Preservation Department – Item 1, LPC-23-08657

**346 Broadway (aka 108 Leonard Street, 46 Lafayette Street) – Former  
New York Life Insurance Building – Individual and Interior Landmark  
Borough of Manhattan**

# DESIGN REVISIONS

## IN RESPONSE TO COMMISSIONER COMMENTS

2 RENDER

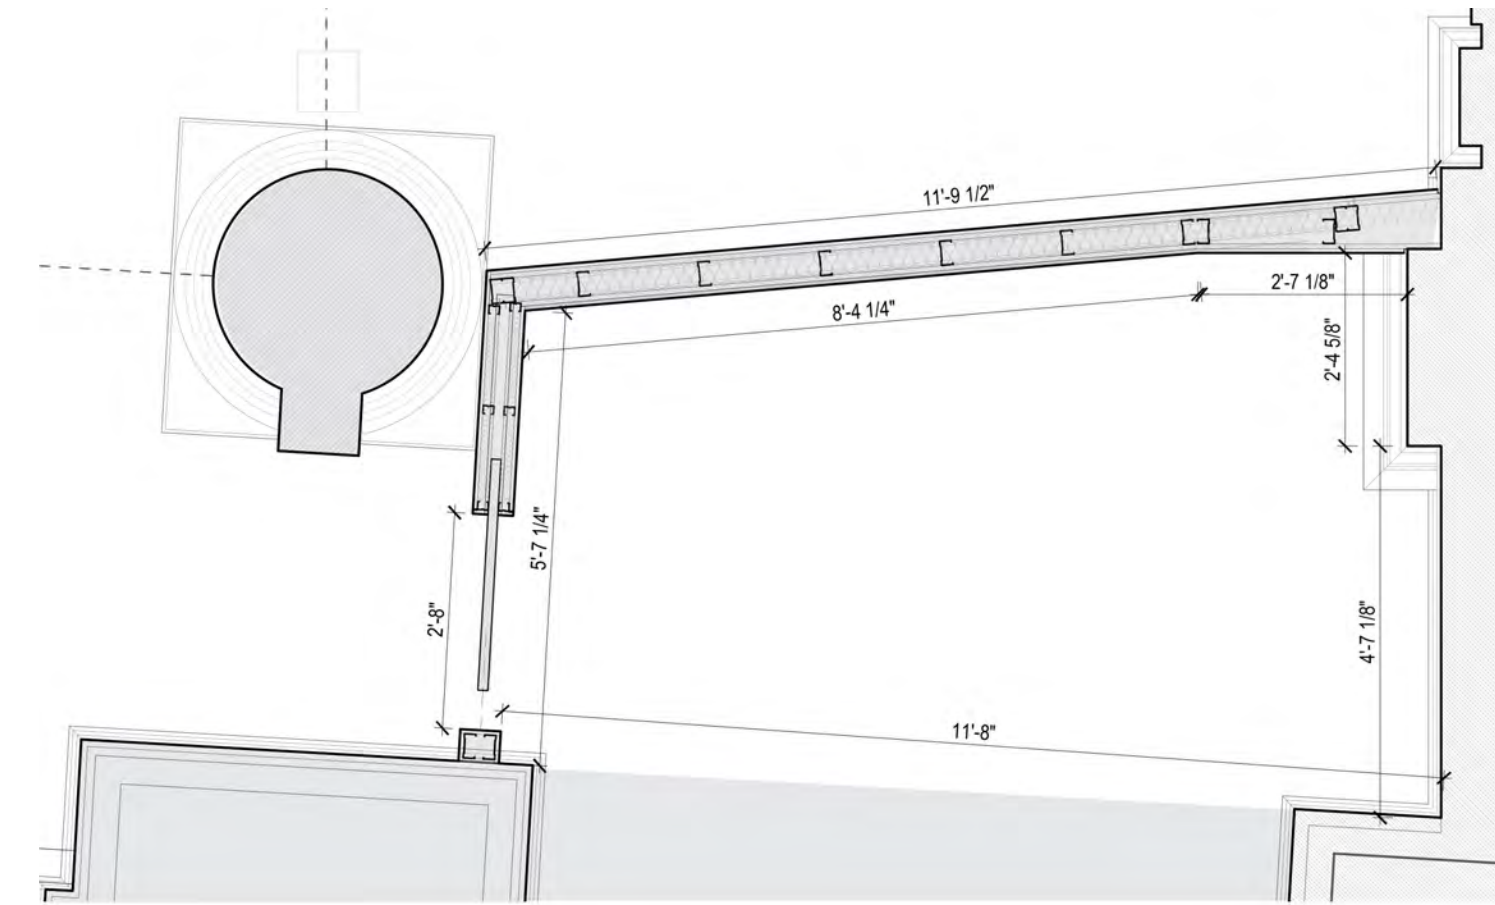
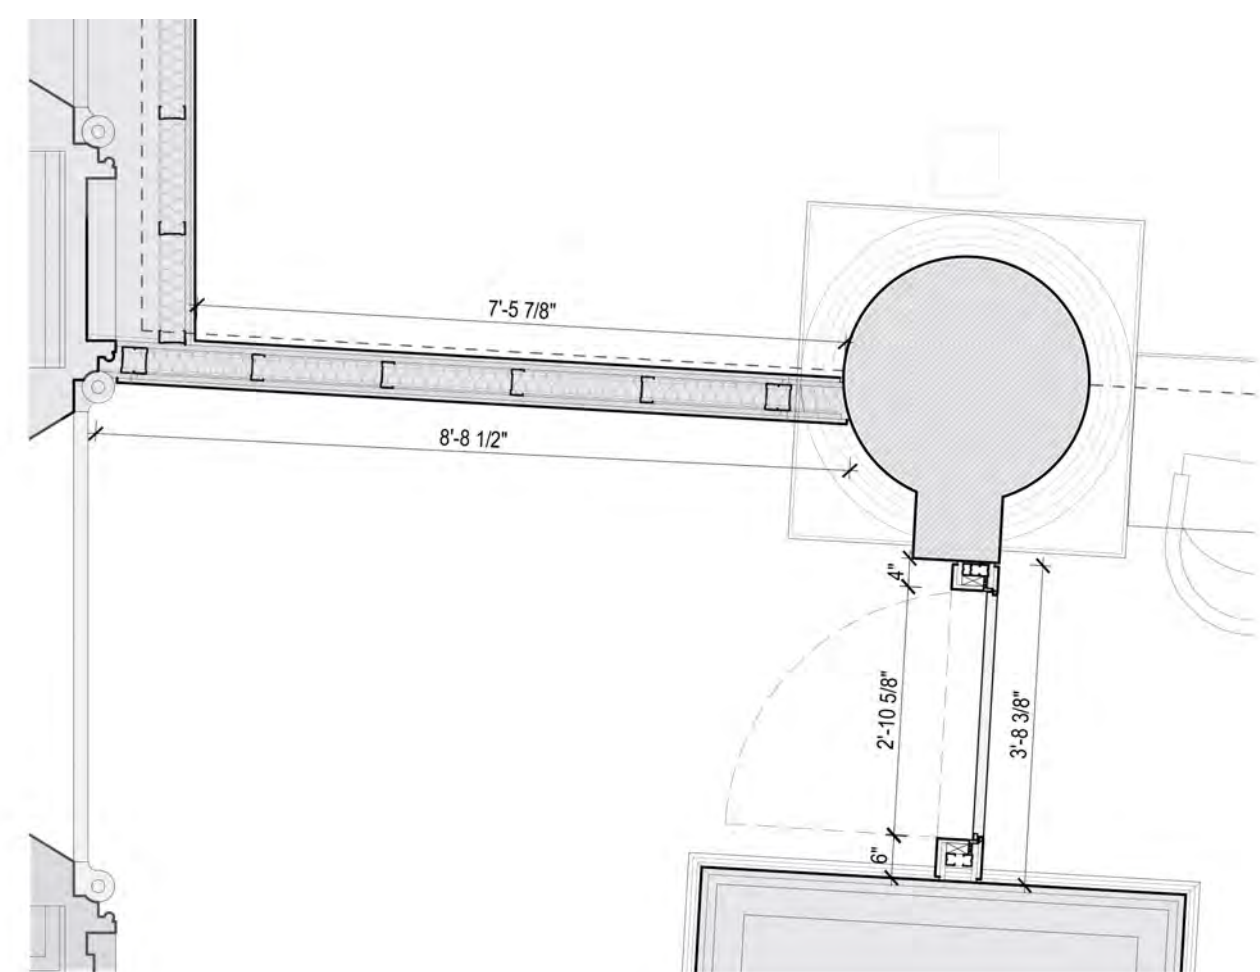
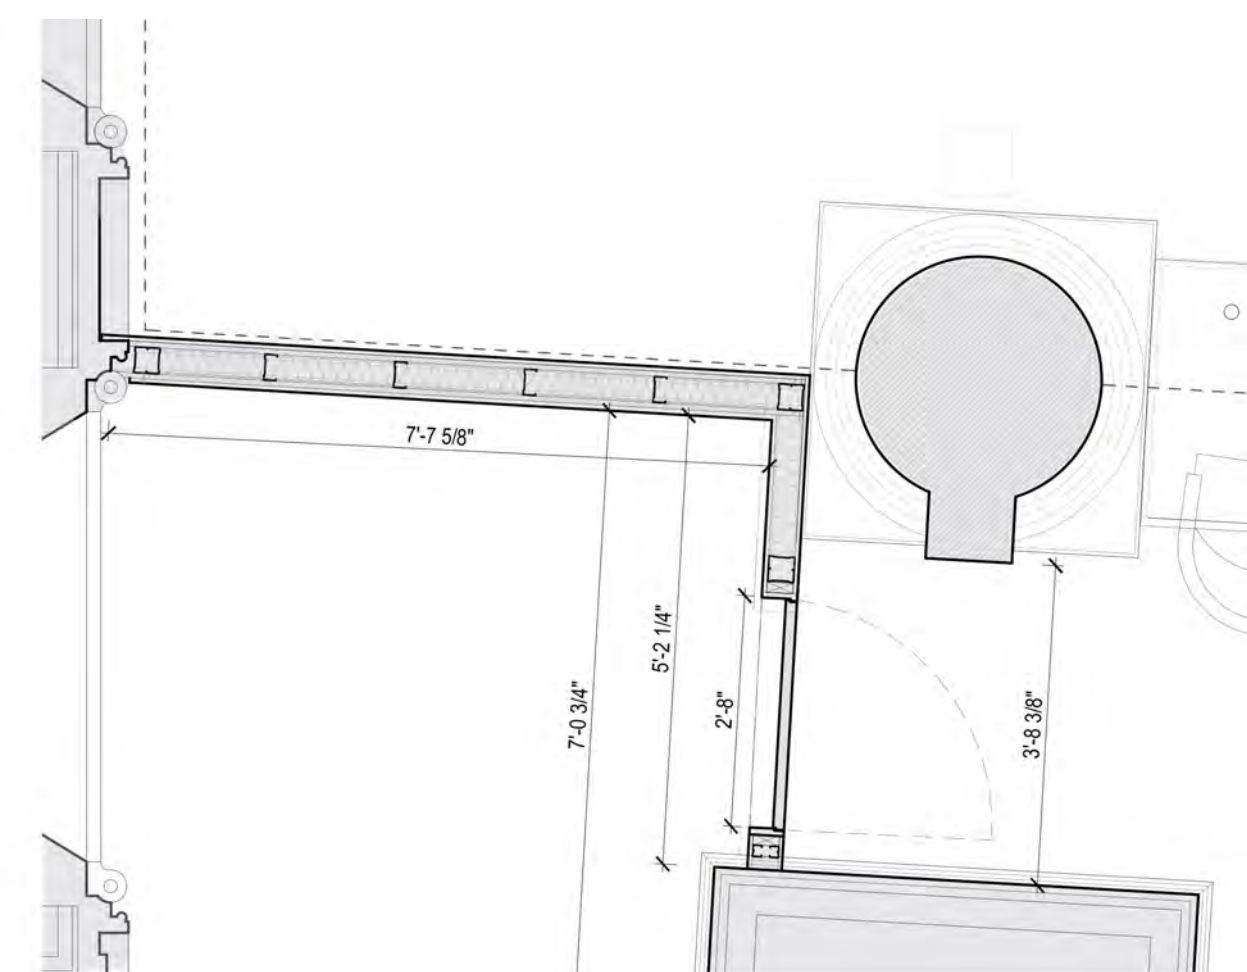
The partitions under the mezzanine have been reconfigured and no longer engage at the columns. The partitioned spaces are tucked behind the column line in deference to the columns while still providing a minimal footprint required for gallery operations

## MEZZANINE NICHE

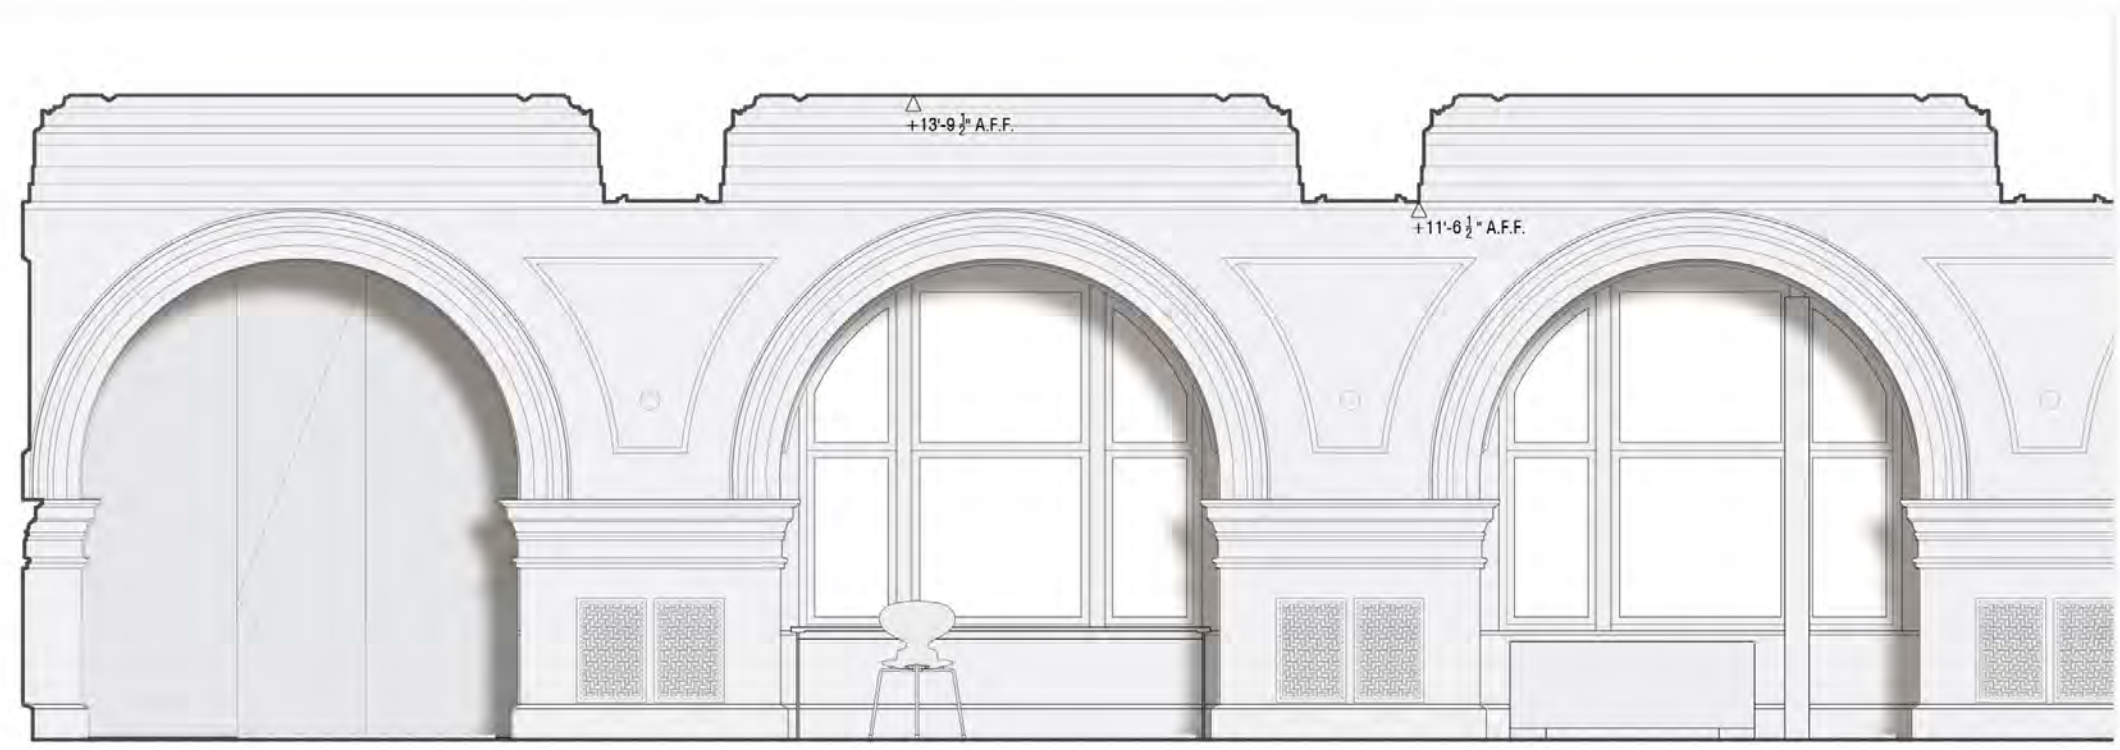
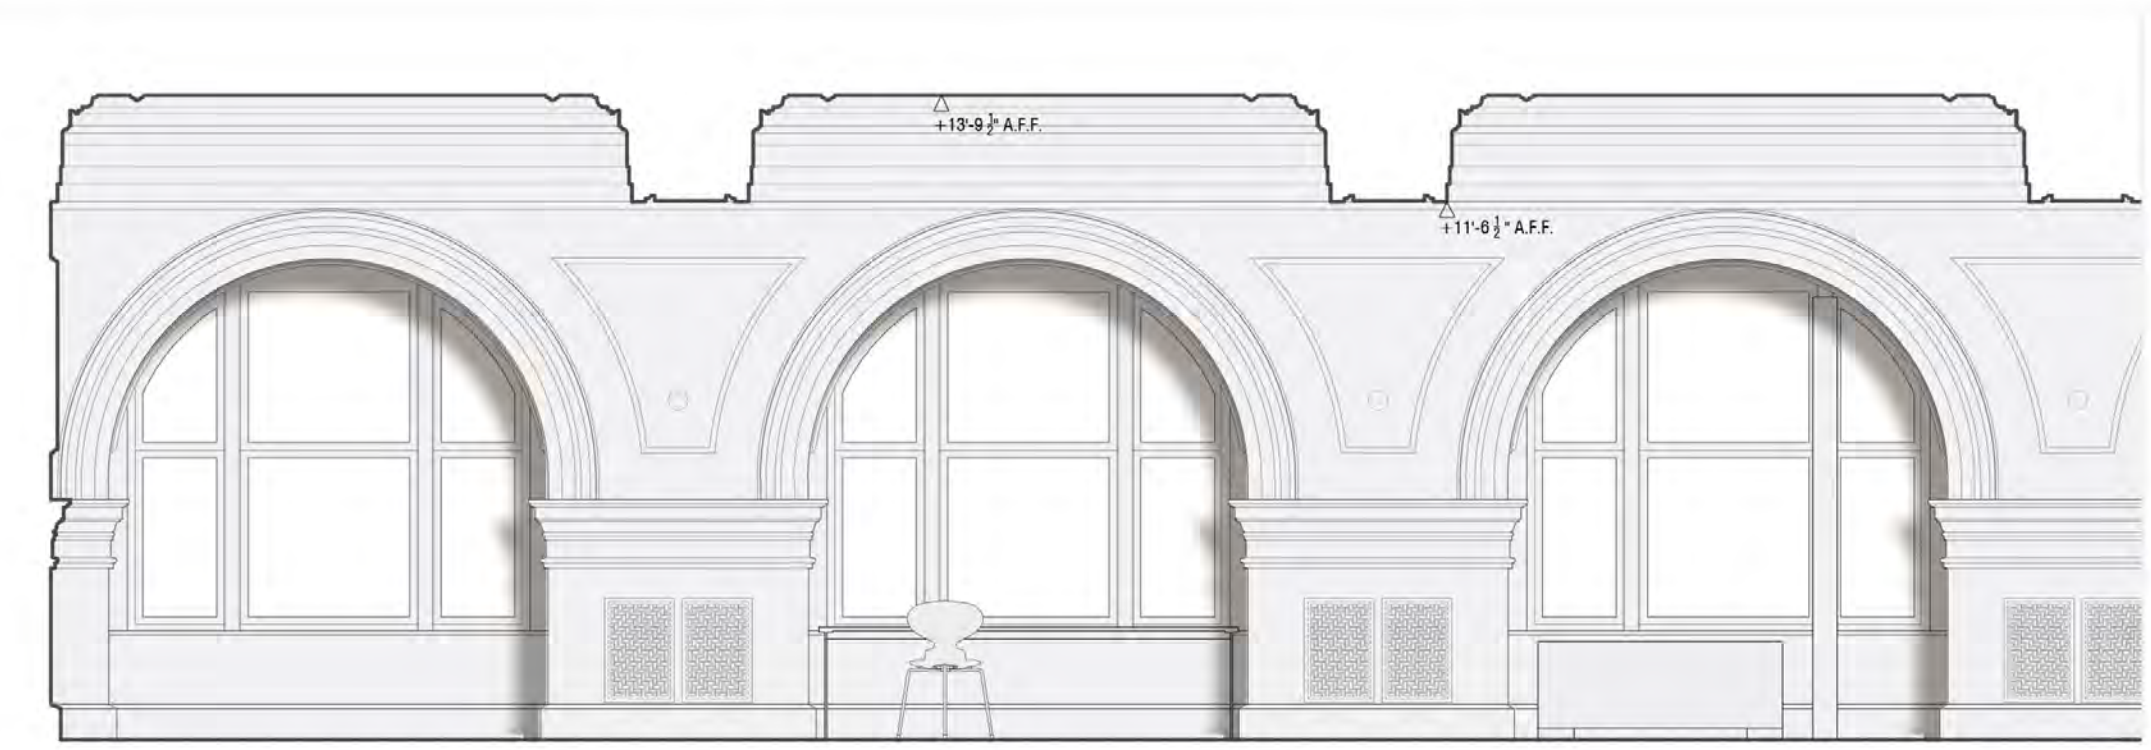
The partition within the window niche has been removed. The window will receive translucent film similar to the other windows.
